Amendments and Additions to the **HIGH SPEED Instruction Manual**

We are furnishing two types of corrections to the manual. The first group consists of "pen and ink" changes, which can be easily marked into your manual. The second group includes lists and diagrams, which you can copy and paste into your manual.

1. PART SUBSTITUTION AFFECTING D-10877 MASTER DISPLAY BOARD (p. 41)

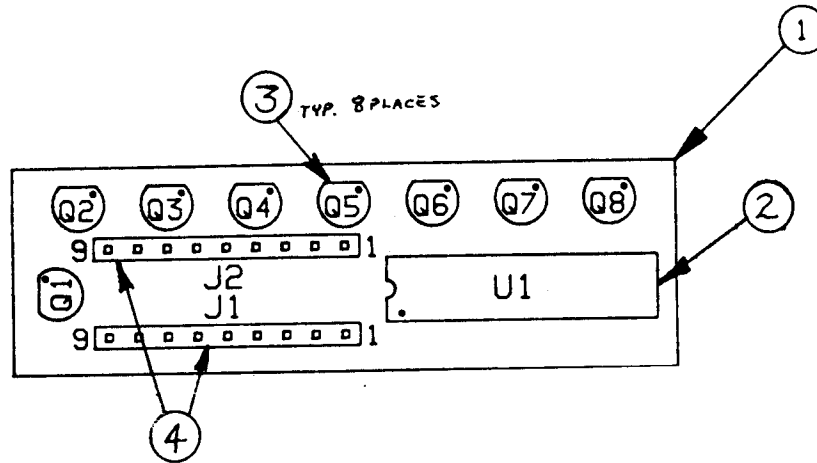
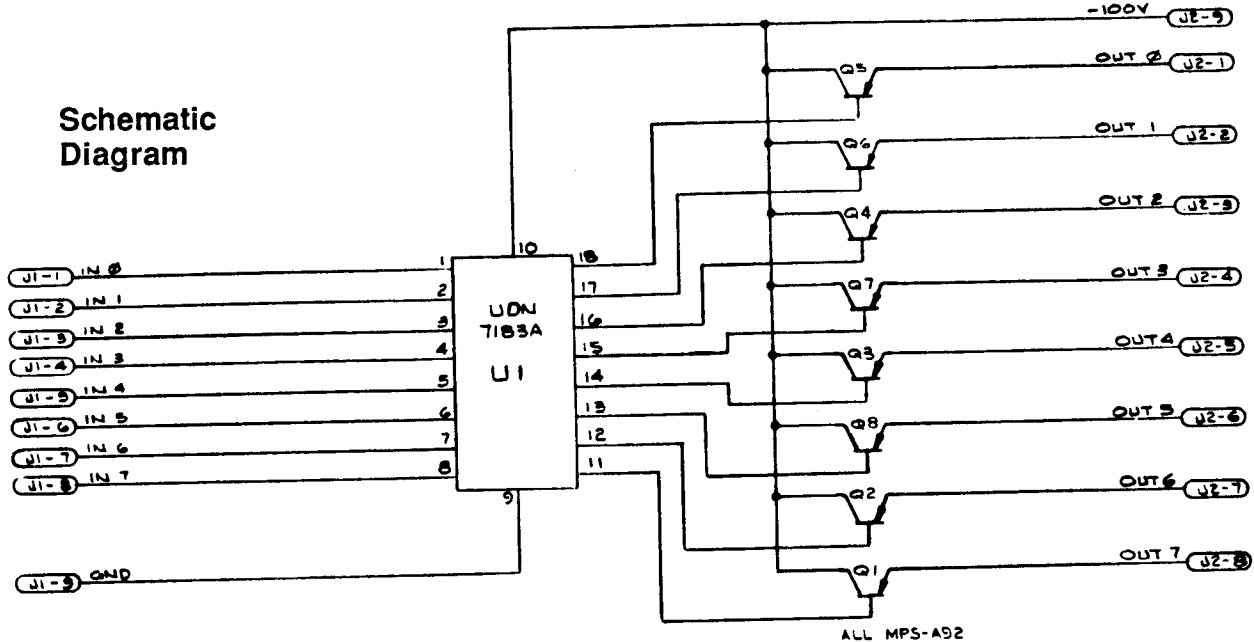
The following assembly may replace the UDN 7180A Cathode Segment Driver because of a temporary IC shortage:

Substitute H V Driver Board Assembly

p/n C-11161

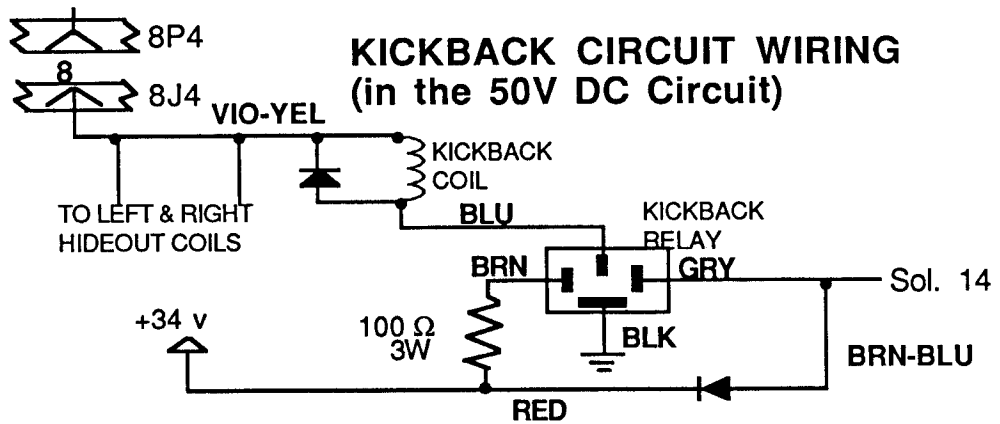
3. Add the following circuit diagram of the Outlane Kickback to the Power Wiring Diagram appearing on page 47.
